TENTATIVE  
CALIFORNIA REGIONAL WATER QUALITY CONTROL BOARD  
CENTRAL VALLEY REGION

ORDER R5-2021-XXXX  
AMENDING WASTE DISCHARGE REQUIREMENTS ORDER R5-2011-0028  
FOR  
TRIANGLE ROCK PRODUCTS, INC  
FLORIN ROAD AGGREGATE PLANT  
SACRAMENTO COUNTY

**ATTACHMENT A**

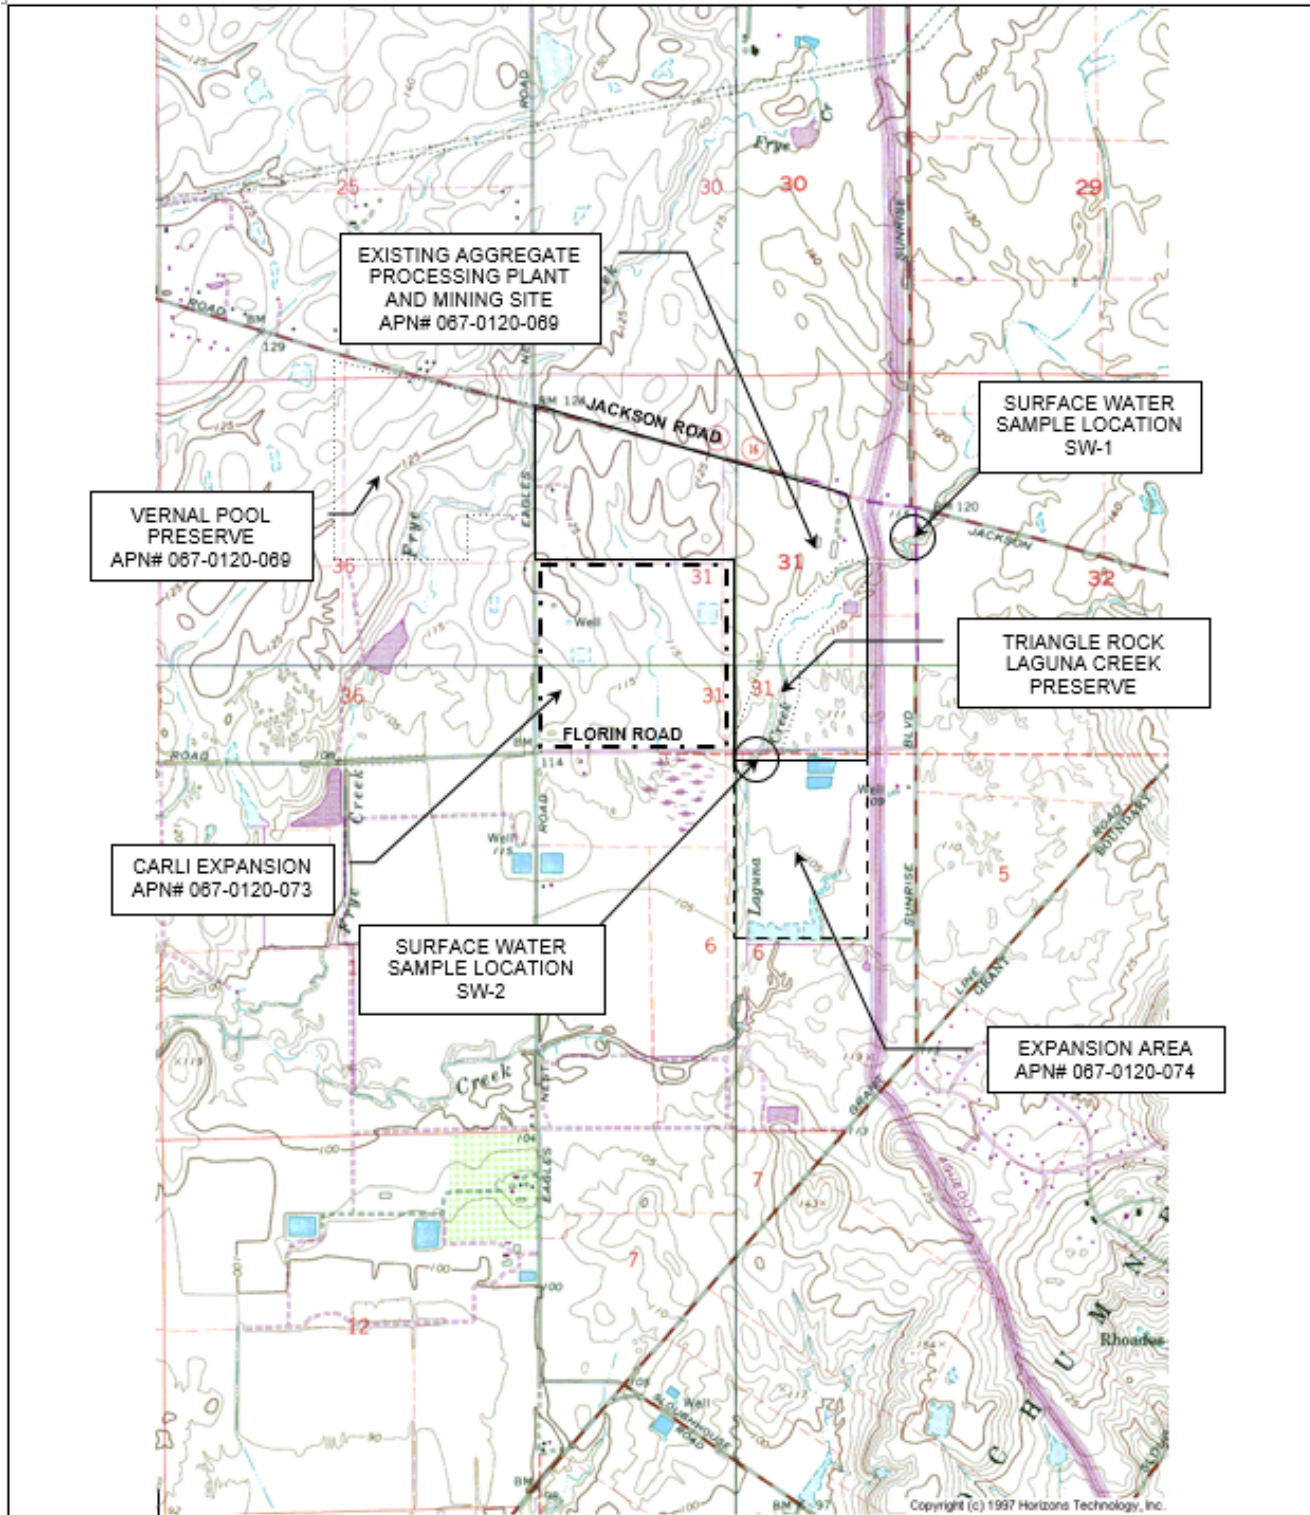
8. Attachment A shall be amended to show the approximate location of the Carli Expansion Area.

*“The Facility is comprised of 413 acres located on property identified by Assessor’s Parcel Number (APN) 067 0120-069 and the 121-acre expansion area (hereafter referred to as Expansion Area) located south of Florin Road and identified by APN 067 0120-074, as shown on Attachment A. Additional mining of sand and gravel will take place on a 161-acre parcel (hereafter referred to as Carli Expansion) and identified by APN 067-0120-073, which is located to the west and adjacent to the Facility.”*

**ATTACHMENT B**

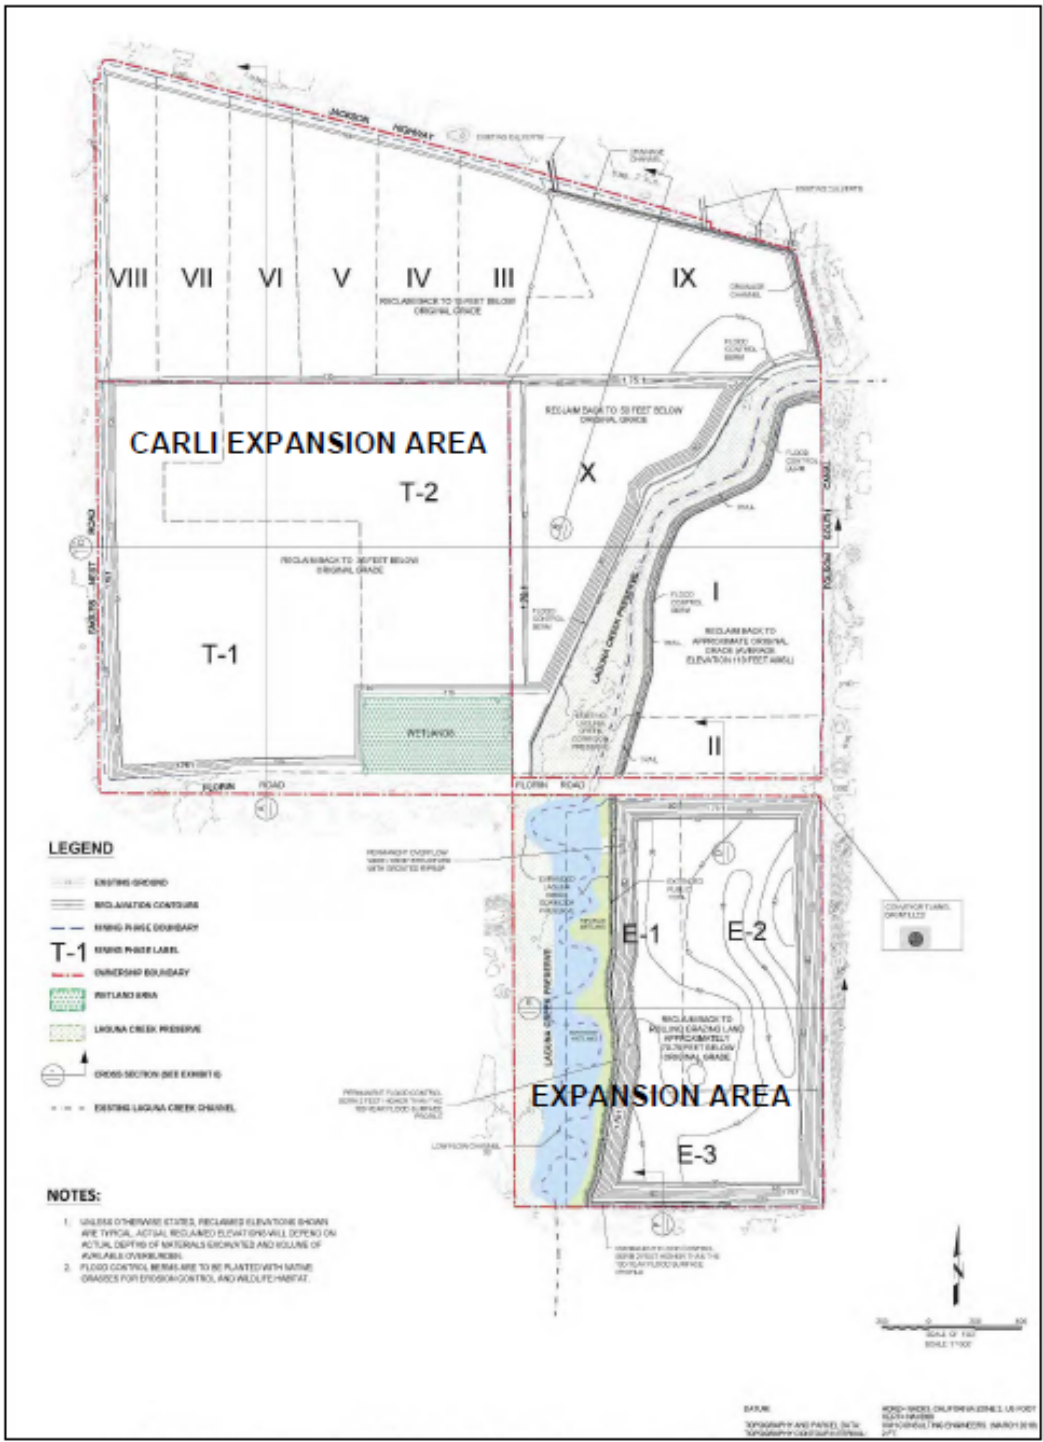
9. Attachment B shall be amended to show the approximate location of the Carli Expansion area.

*“Mining Phases I through VIII have been completed and are in the process of being filled. The remaining phases to be mined include Phase X (the processing plant), Phase IX (future settling ponds), the Expansion Area (Phases E-1, E-2, and E-3), and the Carli Expansion Area (Phases T-1 and T-2). These areas are shown on Attachment B, which is attached hereto and made part of this Order by reference.”*
